SURRY POWER STATION, UNIT NO. 1

AMENDMENT TO FACILITY OPERATING LICENSE

Amendment No. 199
License No. DPR-32

ATTACHMENT TO LICENSE AMENDMENT

ALLOWABLE AIR PARTIAL PRESSURE
SURRY POWER STATION UNITS 1 AND 2

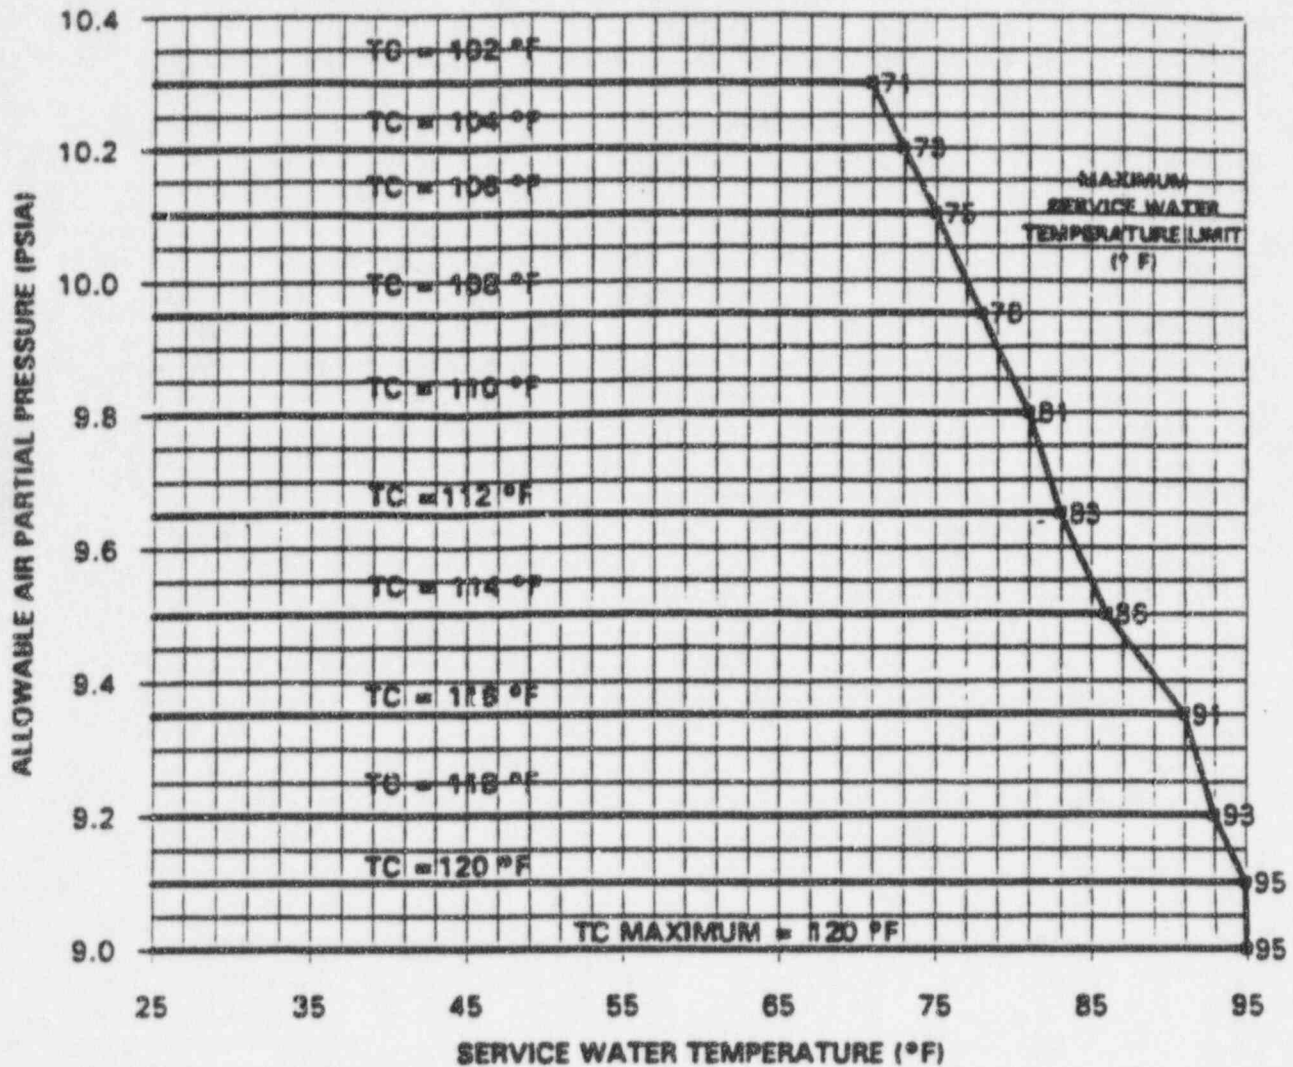
1. Refueling Water Storage Tank temperature $\leq 45^{\circ}\text{F}$, with an 8 hour AOT.
2. Allowable operating air partial pressure in the containment is a function of service water temperature.
3. Horizontal lines designate allowable air partial pressure per given containment average temperature.
4. Each containment temperature line is a maximum for the given air partial pressure.
